September 3, 2008

SUBJECT: ASCE External Review Panel
Review Comments on IPET Draft Final Volume I, *Executive Summary and Overview*, and Draft Final Volume VIII, *Engineering and Operational Risk and Reliability Analysis*

Figure 1 – Graphical Representation of IPET Results

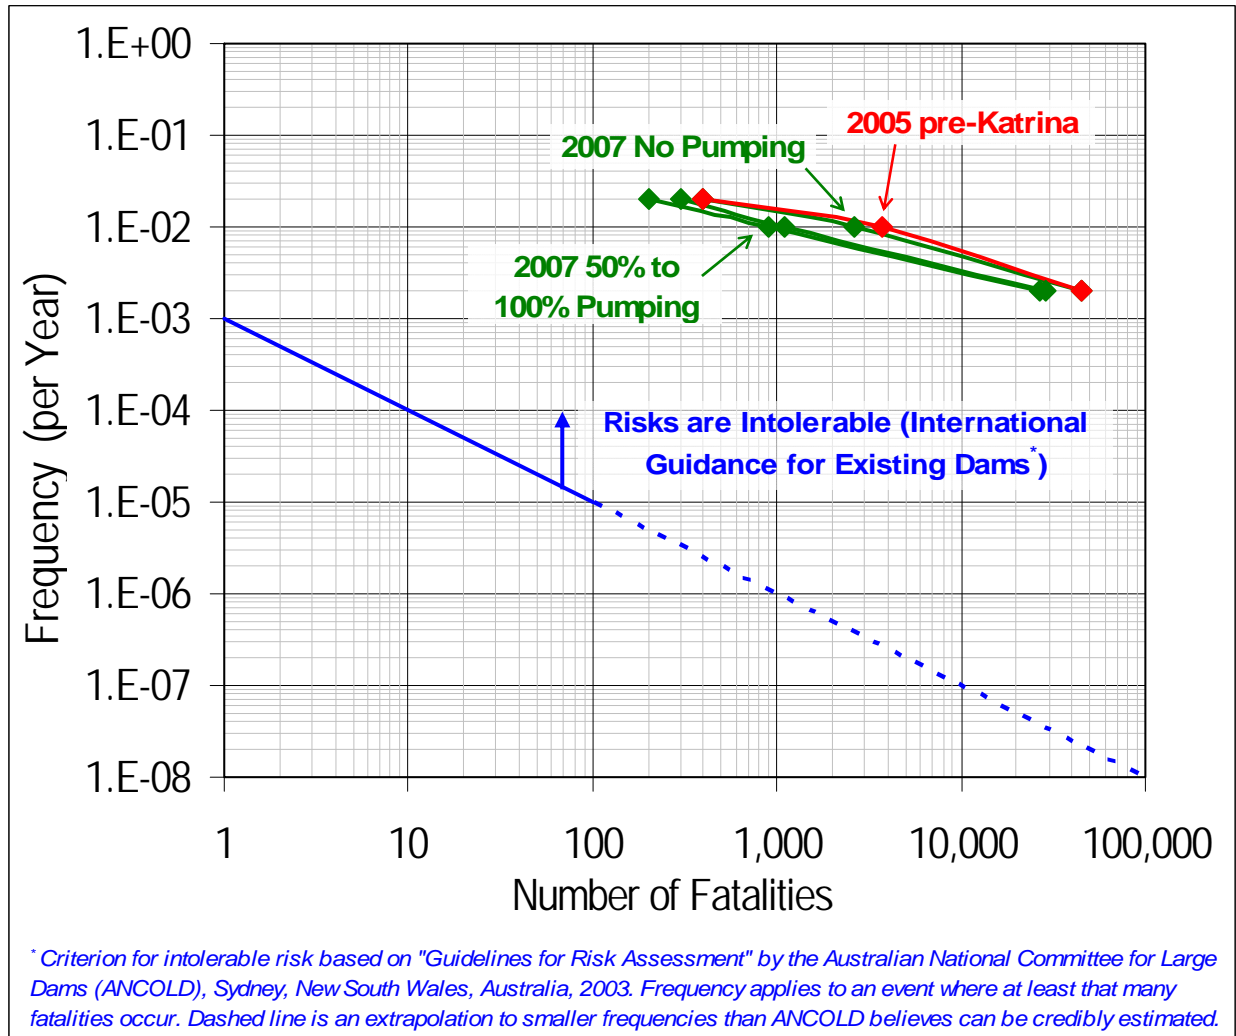
We do believe, however, that the findings on risk need to be put into a larger context in both volumes. For example, Figure 1 (attached) presents the IPET results in a chart where the annual frequency of hurricane flooding is plotted against the number of predicted casualties. This chart shows the risk associated with the HPS pre-Katrina and as of June 2007. The chart illustrates that

the difference between pre-Katrina and June 2007, primarily due to the installation of closure gates on the outfall canals, is relatively small in comparison to what would be needed to significantly reduce overall risk in New Orleans. Also on this chart, the HPS can be compared and contrasted to international standards for large dams. While these standards for dams were not intended to be applied to levees, Figure 1 underscores the urgent need for a national dialogue to generate meaningful standards for levees.
